Planning Commission Staff Report

Project Type: Amended Site Development Plan

Meeting Date: February 22, 2016

Description: **Four Seasons Plaza, Lot 2 (Panera Bread)**: An Amended Site Development Plan, Amended Landscape Plan, Partial Amended Lighting Plan, Amended Architectural Elevations and an Architect's Statement of Design for an 8.29 acre tract of land zoned "PC" Planned Commercial District located on the south side of Olive Boulevard west of its intersection with Woods Mill Road.

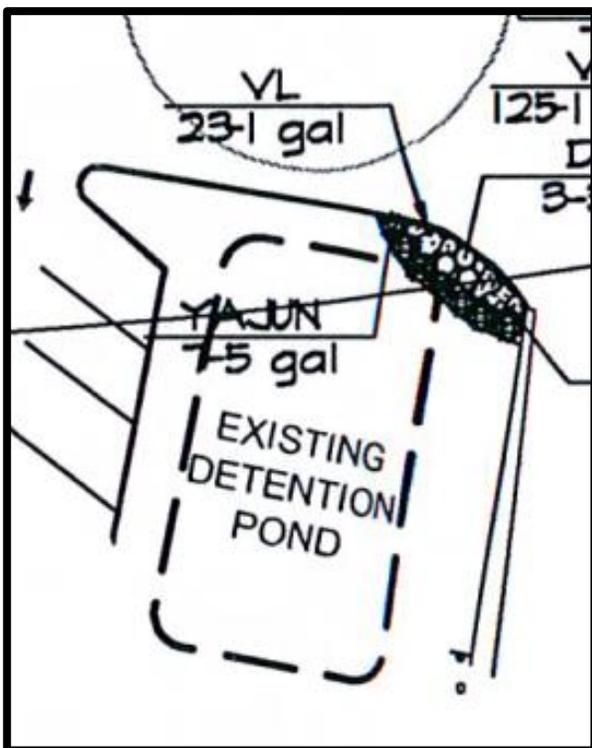
The amendments to the Architectural Elevations include slightly increasing the height of the subject area, as shown in the comparison below. Whereas the existing endcap space is dwarfed by the adjacent portion of building, adding height to the building will alter the scale to be more consistent with the adjacent section of the building. The canopies and wainscot provide a pedestrian scale despite the height increase.

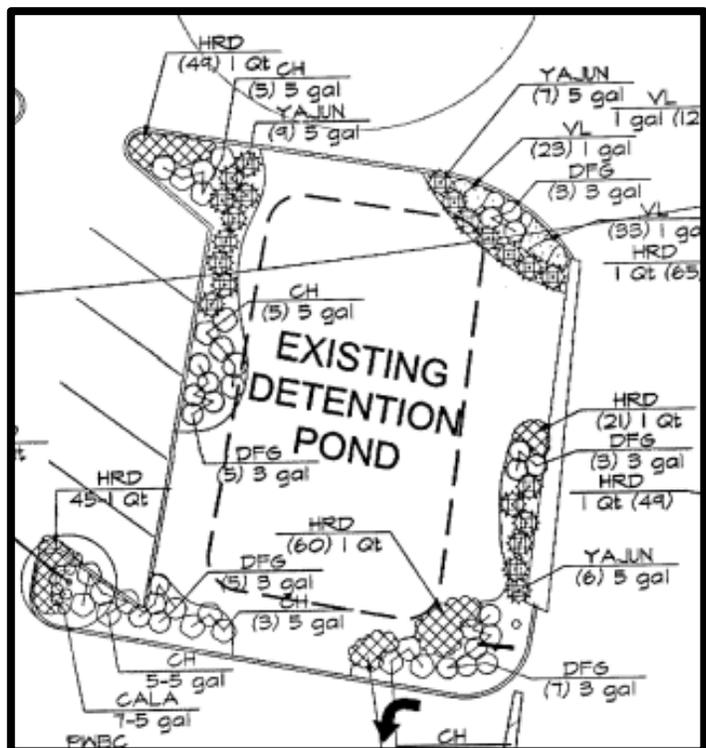
3. Additionally, the ARB suggested that the applicant consider replacement of and/or additional landscaping around the split rail fence that surrounds the detention area north of the subject tenant area.

Finally, in response to the ARB's third recommendation, the applicant has revised the Landscaping Plan to include substantial landscaping around the split rail fence and detention area. Below is a side by side comparison of this area.

Landscaping around detention area as presented at ARB

Landscaping around detention area in current Landscape Plan
